Proposal for amendments to Draft new Regulation on uniform provisions concerning the approval of enhanced Child Restraint Systems used onboard of motor vehicles

The text reproduced below was prepared by the expert from the Netherlands. It is based on Informal Document No. GRSP-49-39 including the modifications made during the 26th session of the informal group and the discussions of the group during that session. The modifications to the proposed text contained in that document are marked in underline or strikethrough characters.

Figure 1: Side view of the support leg dimension assessment volume"

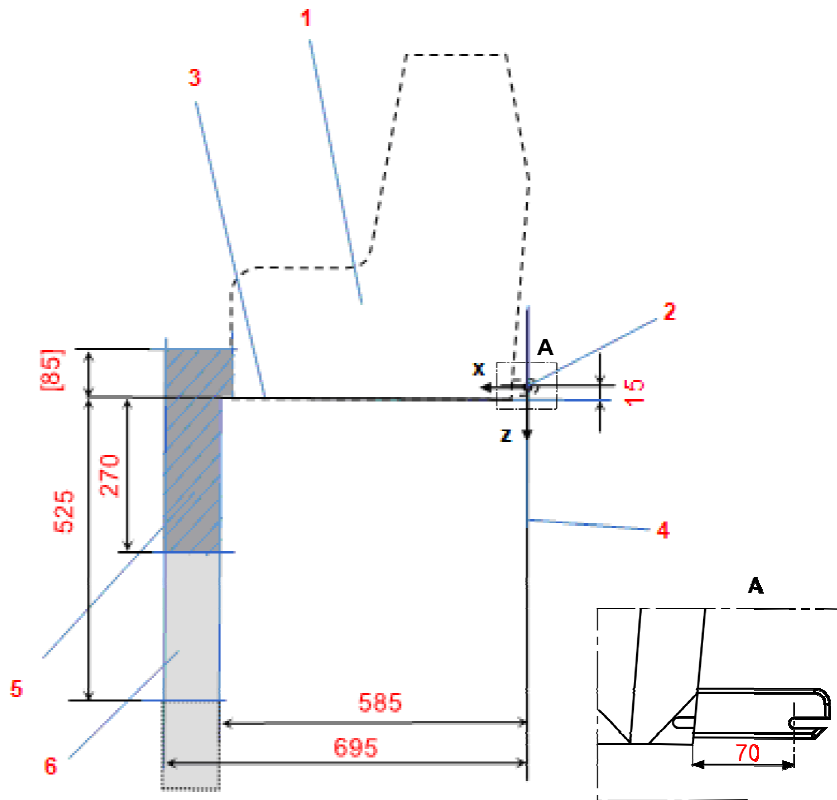
Paragraph 6.3.5, amend to read:

"6.3.5. The geometrical requirements in paragraphs 6.3.5.1. to 6.3.5.4. are referenced to a coordinate system, whose origin is located centrally between the two ISOFIX attachments and on the centreline of the corresponding ISOFIX anchorage system. The centreline of the corresponding ISOFIX anchorage system here is located 70 mm behind the rearmost lower corner of the CRF as indicated in Annex 19, Figure 1."

Paragraph 6.3.5.:

The "corresponding ISOFIX anchorage system" means the ISOFIX brackets mounted on the vehicle. Since this Regulation is about the approval of the CRS itself, there is no corresponding vehicle and therefore no corresponding ISOFIX anchorage system available. In other words we do not know the location of the "corresponding ISOFIX anchorage system" in relation to the CRS. Since normally the ISOFIX attachments are adjustable we need to know how much these attachments must be adjusted before determining support-leg and -foot volumes.

If we assume the "corresponding ISOFIX anchorage system" to be located 70 mm behind the rearmost lower corner of the CRF we have a fixed relation between the CRF and the origin of the coordinate system.

The dimension of 70 mm is taken from Figure 0(b) which is based on the description from ISO 13216-1 (Note 2 and Figure 2).
